TOWN OF LEE
32 Main Street, Lee, MA 01238
www.lee.ma.us

TO: EPA/GE
FROM: Town of Lee
DATE: July 12, 2023
RE: Preliminary Comments to PCB Transportation Plans

The Town of Lee would like to submit the following preliminary comments regarding the draft PCB transportation plans presented by General Electric on June 27, 2023.

Town of Lee, MA - Proposed Truck Routes of Out of State PCB Transport

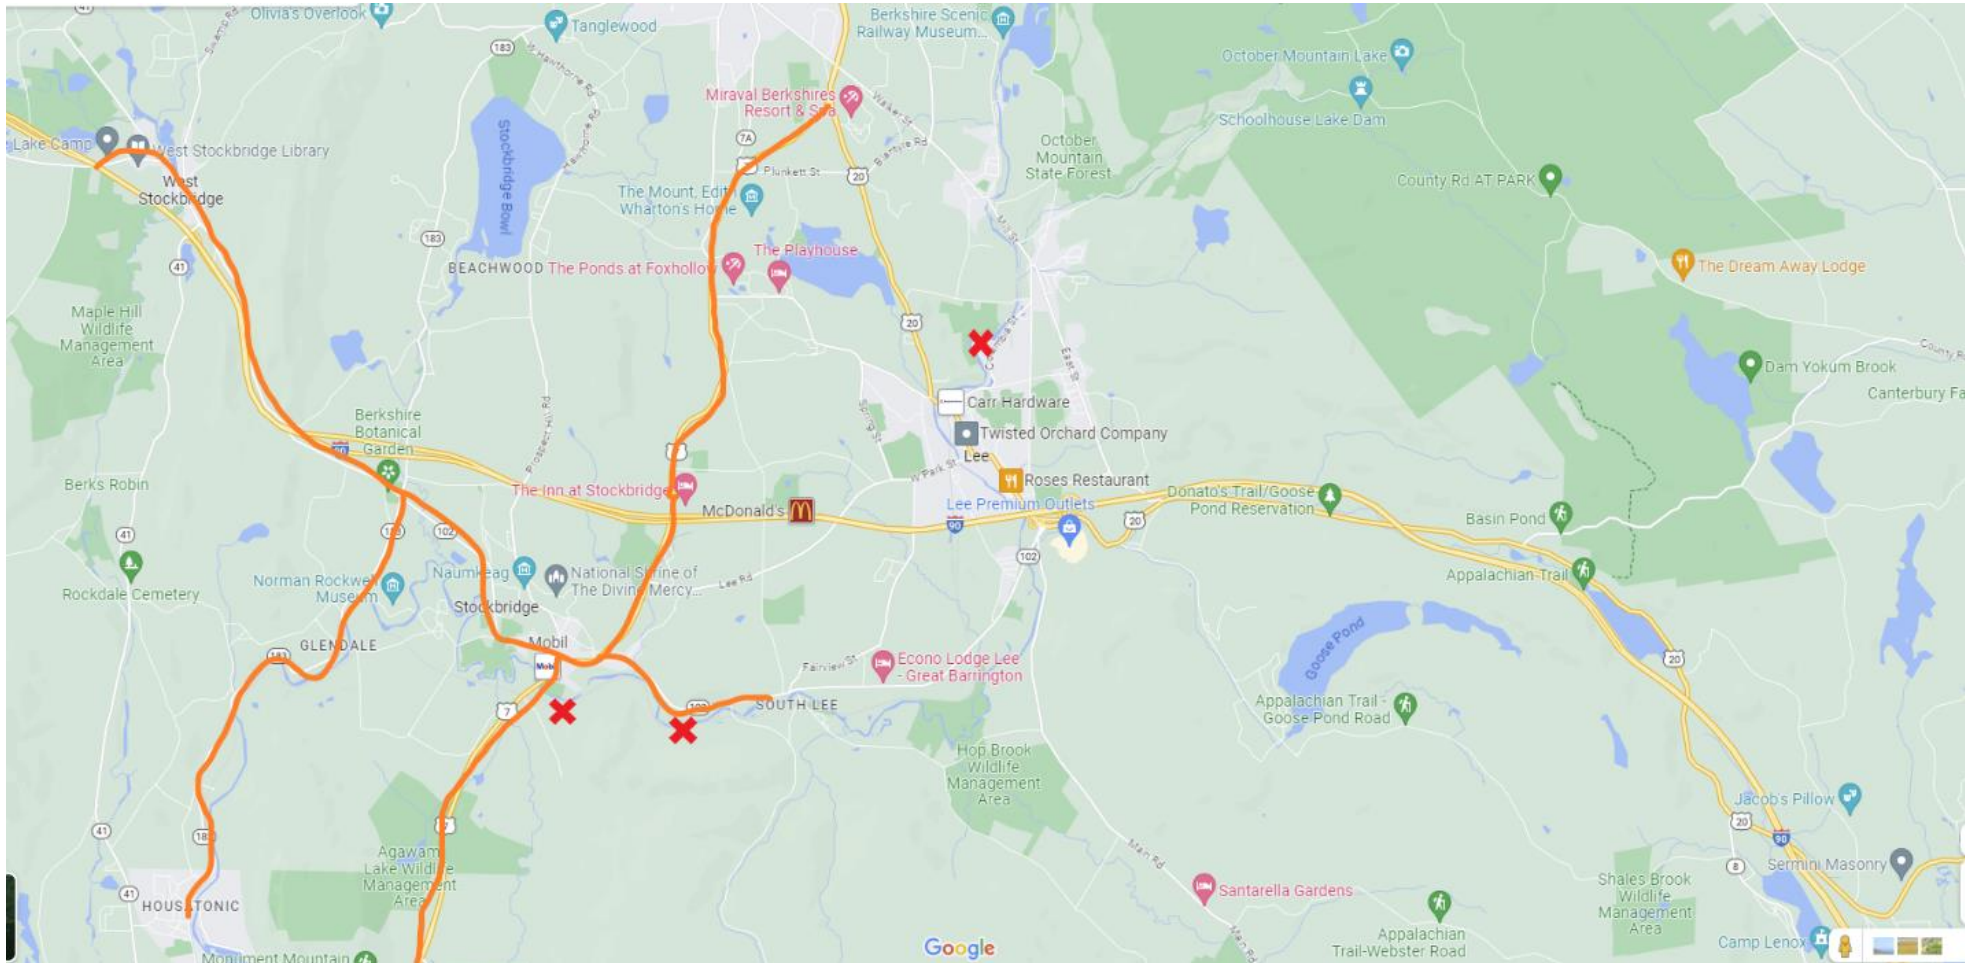
6. If railroad is not the chosen method of transport for out of state materials the Town of Lee requests that all materials enter the Turnpike in West Stockbridge following the routes proposed in Attachment A of this document.

NOTE: West Stockbridge entrance to route 90 would require a special access point (or service entrance) for west bound traffic OR Route 90 could be accessed at B3 (New York)
